**LEXINGTON-FAYETTE URBAN COUNTY  
 GOVERNMENT CONTRACT CHANGE ORDER**  
 Page 1 of 2

Date	February 14, 2017
Project	Fire Station #2 Replacement
Location	Lexington
Contract No	013-2016
Original Contract Amt	\$4 618 900 00
Cumulative Amount of Previous Change Orders	\$17 801 88
Percent Change - Previous Change Orders	0 39%
Total Contract Amount Prior to this Change Order	\$4 636 701 88
Change Order No	7

**Work Changes Proposal Request No. 10**

**Project:** 13117 Lexington Replacement Fire Station No. 2  
City Job No. 161-2015/038-2016

**A1** PR 10 EC Dorm 111 Plan  
1/8" = 1'-0"

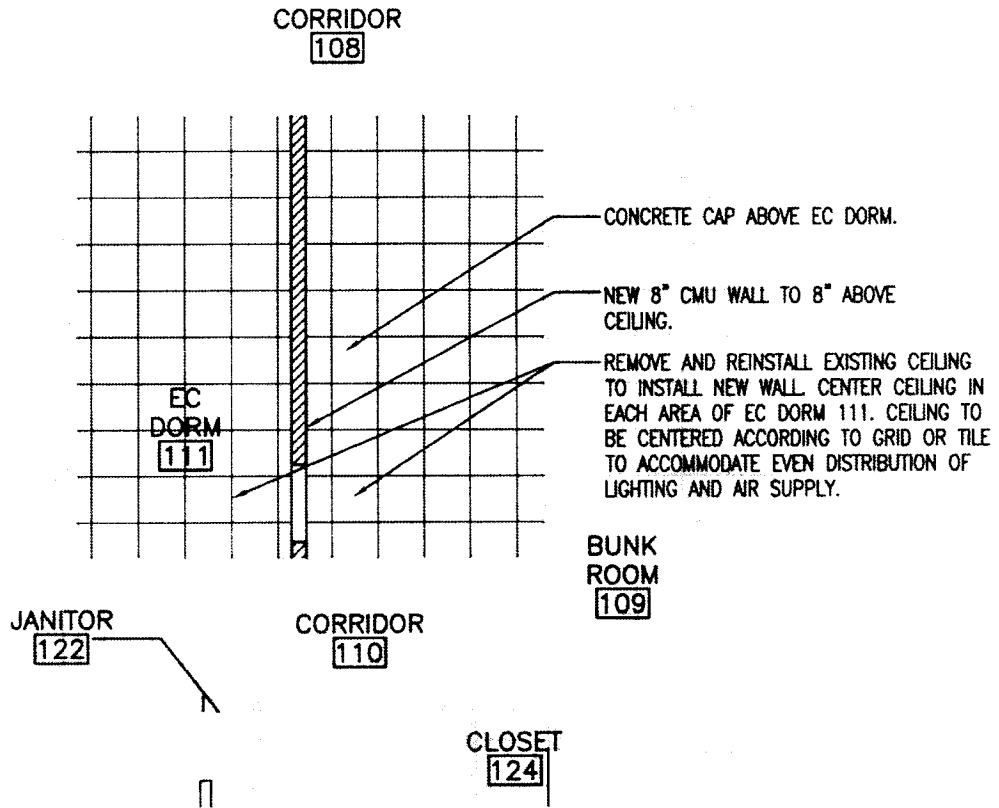
- ③ Add intercom station at exterior side of Door 101A per PR 10.10.
4. See PR 10.1-PR 10.2 for modifications for EC Dorm 111 adding new CMU wall to create separate sleeping and sitting areas. See PR 10.7-PR 10.10 for Modifications to Mechanical and Electrical Items related to EC Dorm 111.

PROJECT NO. 13117  
 DATE 1/11/2015  
 C-101  
 BRASHEAR ENGINEERING  
 1000 EASTLAND DRIVE  
 SUITE 100  
 MURRAY, MISSOURI 64575  
 PHONE 417-241-1111  
 FAX 417-241-1112  
 WWW.BRASHEAR-ENGINEERING.COM

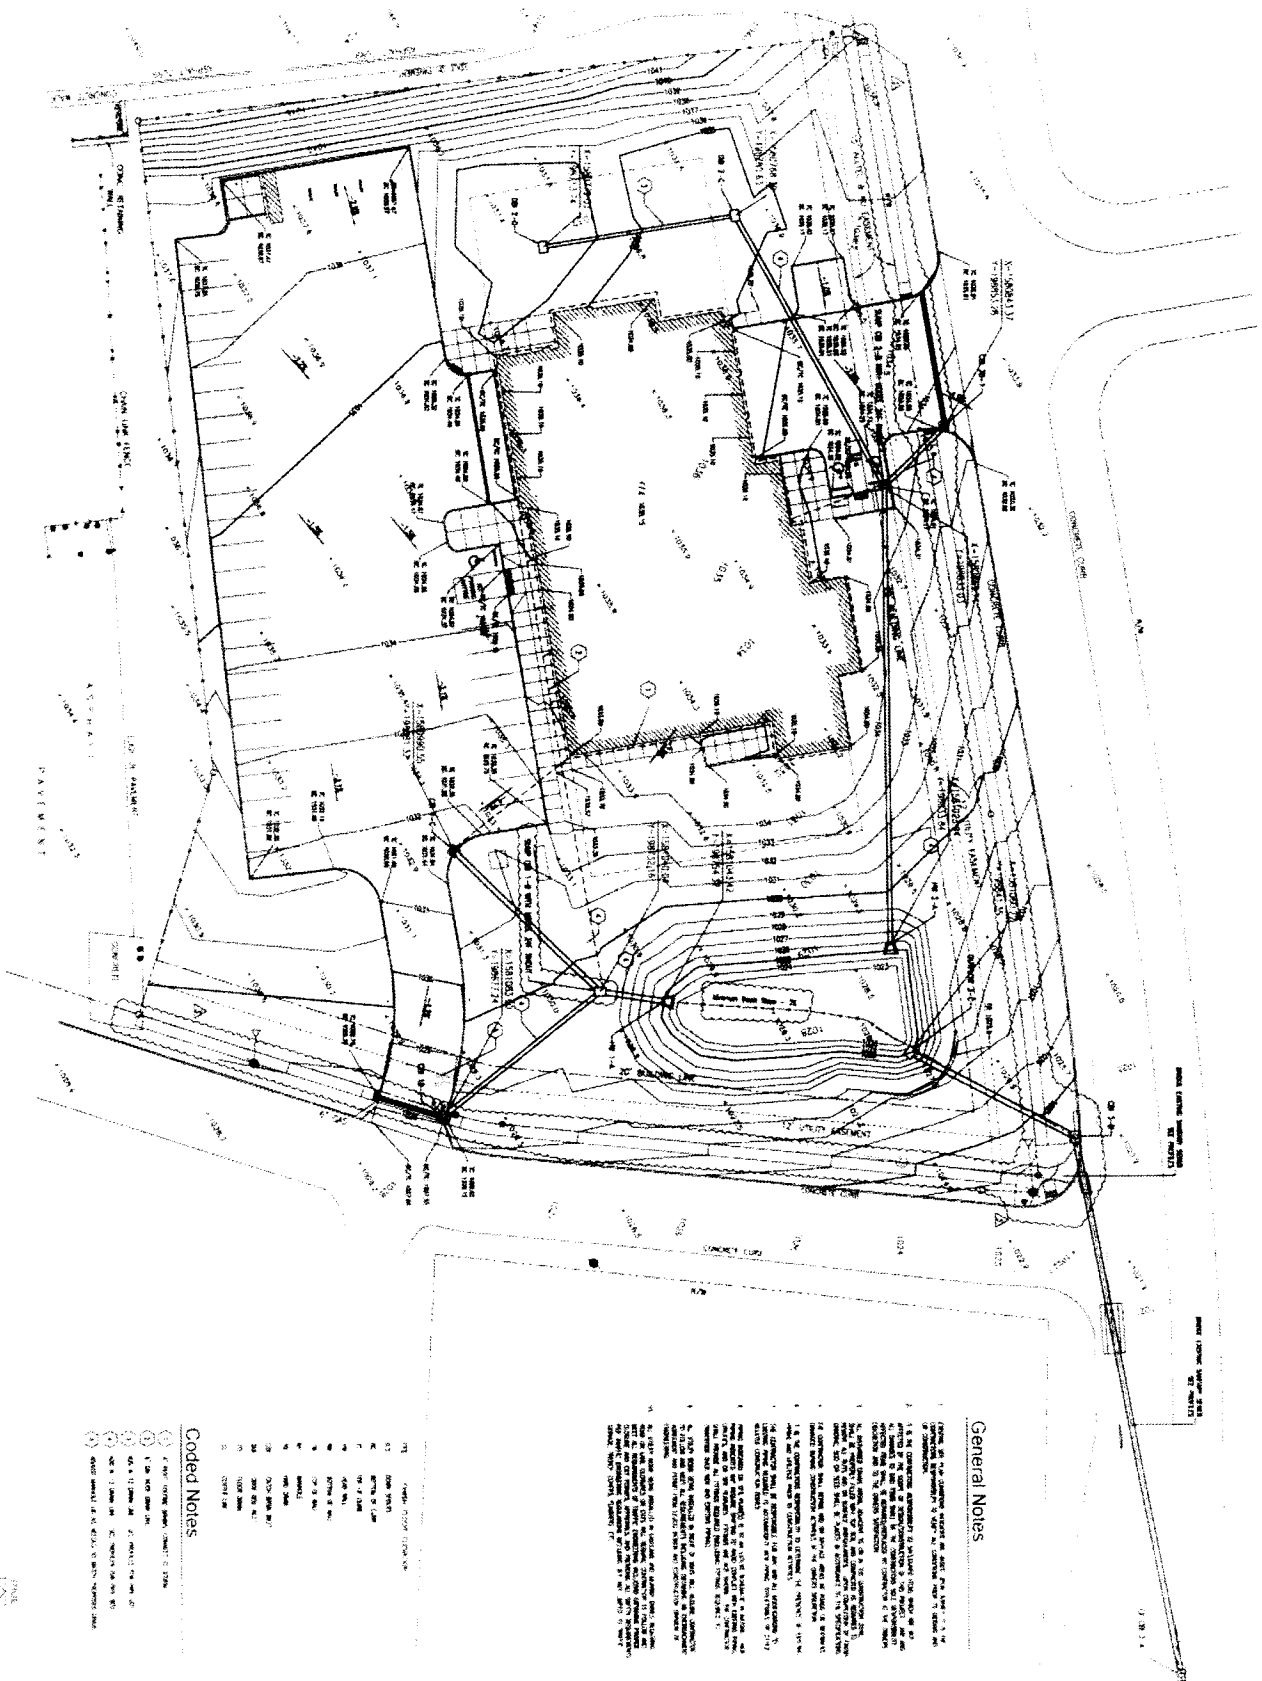
5. Add sidewalk and Tactile Warning Strips along Eastland Drive as shown in PR 10.3 and PR 10.4 per LFUCG Standards.
6. Modify existing apron and curbs at Eastland Drive as shown in PR 10.3 and PR 10.4. per LFUCG Standards.

7. Add sidewalk and Tactile Warning Strips along Murray Drive as shown in PR 10.3 and PR 10.4 per LFUCG Standards.
8. Modify existing apron and curbs at Murray Drive as shown in PR 10.3 and PR 10.4. per LFUCG Standards.
